# Field Modification of Ten-Tec model 516 Argonaut to Reduce Potential of SSB TX Distortion.

## About this Modification:

**Figure 3. Modified Model 516 Logic Board.**

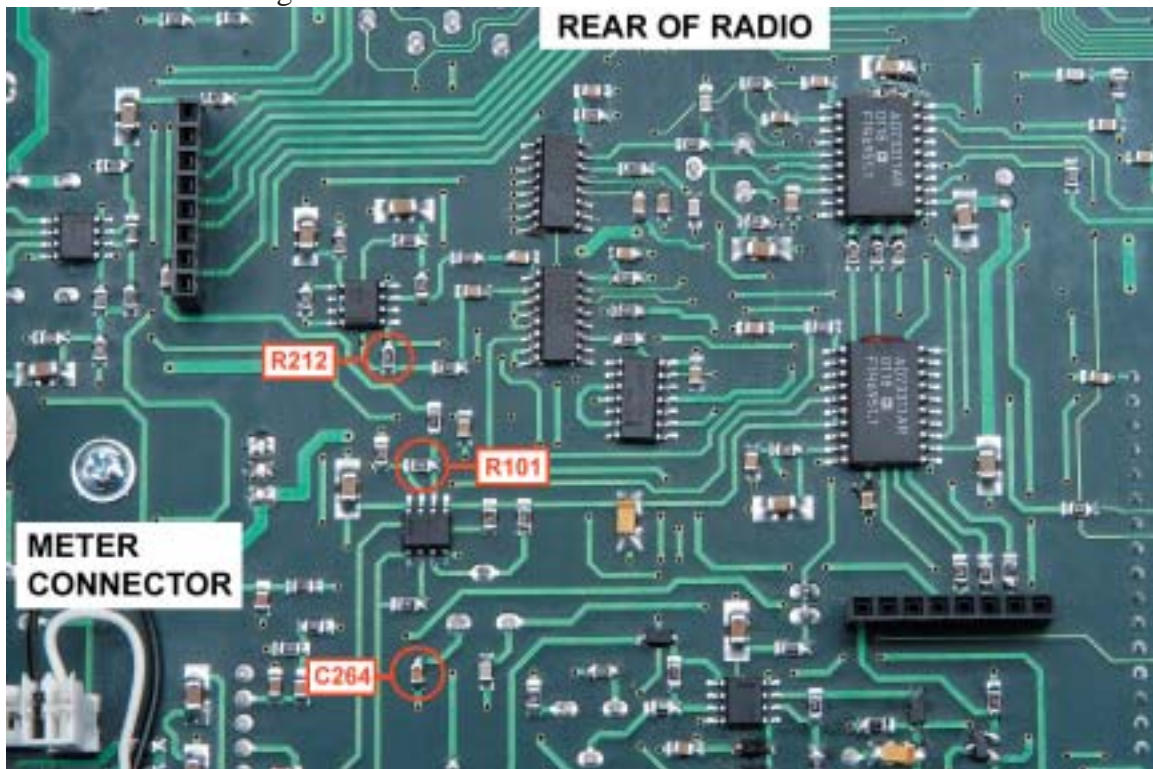
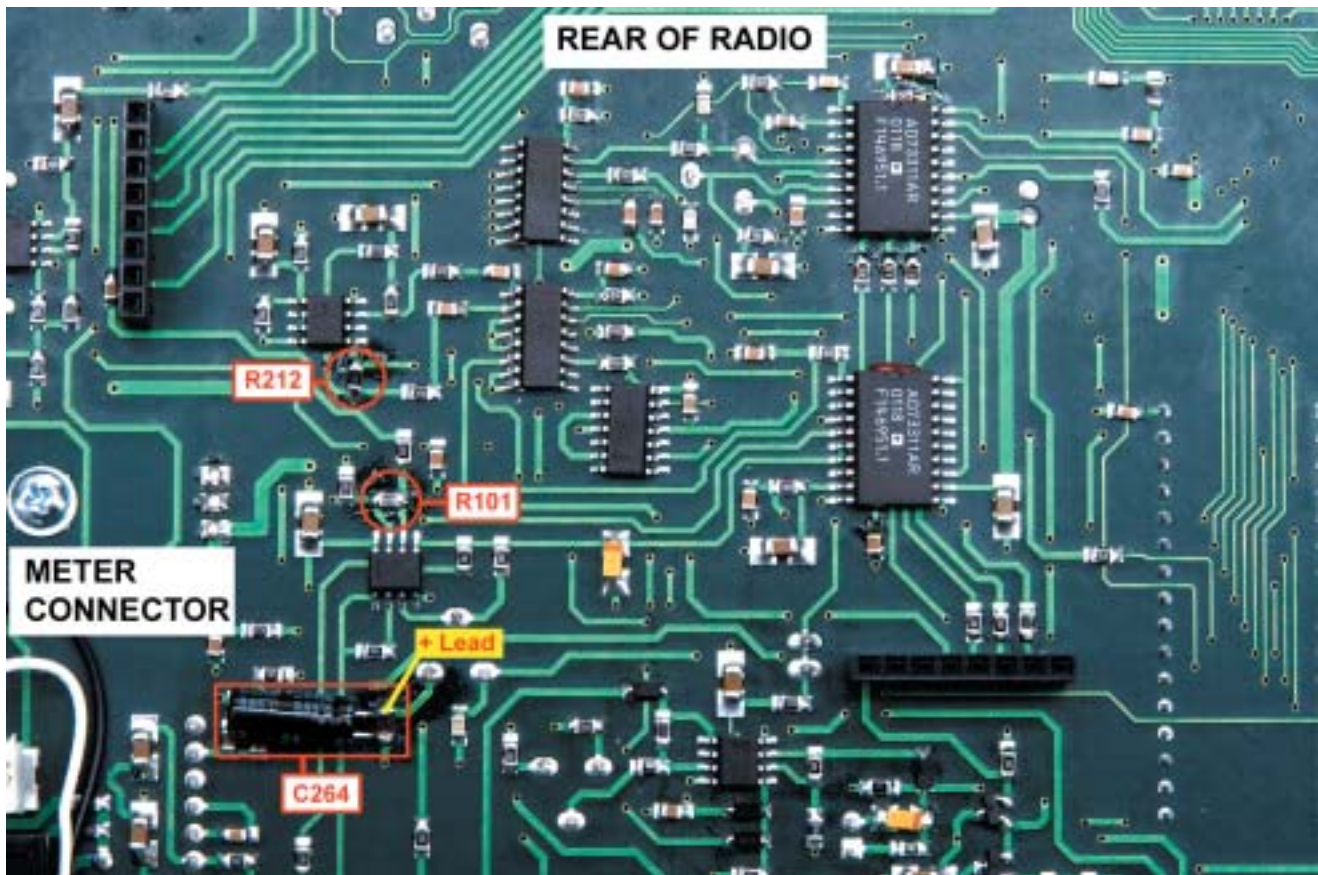
- 2) Locate the short piece of Solder-Wick braid and carefully remove solder from each end of R212. While alternately heating each end of the resistor carefully apply a slight upward pressure with the soldering iron tip to remove the old 4.7K ohm [472] resistor. You will need to break the part loose from the glue holding it in place while the solder is hot. CAUTION: The pads can easily be damaged or lifted from the board. Use the minimum amount of heat and force necessary to remove the part.

- 5) Locate the new 10K ohm [103] resistor, and using a small pair of tweezers, position it across the pads in the same position as the old resistor. While holding it in position, touch the tip of the soldering iron to one end of the resistor and its corresponding pad, letting the solder melt thoroughly before removing the soldering iron tip. In like manner, solder the other end of the resistor to its pad.

- 6) Carefully inspect the connections with a magnifier and if necessary reheat the connections, applying extra solder if needed.
- 7) Locate the short piece of Solder-Wick braid and carefully remove solder from each end of R101. While alternately heating each end of the resistor carefully apply a slight upward pressure with the soldering iron tip to remove the old 100K ohm [104] resistor.

- 8) Locate the small piece of solder and carefully apply a thin coating of fresh solder to the pads. There is no need to re-glue the new parts.
- 9) Locate the new 47K ohm [473] resistor, and using a small pair of tweezers, position it across the pads in the same position as the old resistor. While holding it in position, touch the tip of the soldering iron to one end of the resistor and its corresponding pad, letting the solder melt thoroughly before removing the soldering iron tip. In like manner, solder the other end of the resistor to its pad.

- 10) Carefully inspect the connections with a magnifier and if necessary reheat the connections, applying extra solder if needed.
- 11) Locate the short piece of Solder-Wick braid and carefully remove solder from each end of C264. While alternately heating each end of the resistor carefully apply a slight upward pressure with the soldering iron tip to remove the old chip capacitor.

- 13) Locate the new 2.2mfd. electrolytic capacitor. Carefully bend and trim the leads as shown below in Figure 2.

- 14) Referring to Figures 2 and 3 solder the new 2.2mfd. electrolytic capacitor in the same place as the previous C264 chip capacitor. Be sure the positive(+) lead of the capacitor is soldered to the pad which is closest to the rear of the Logic Board.
- 15) Inspect all solder connections and make sure the modified Logic Board looks like that shown in Figure 3.
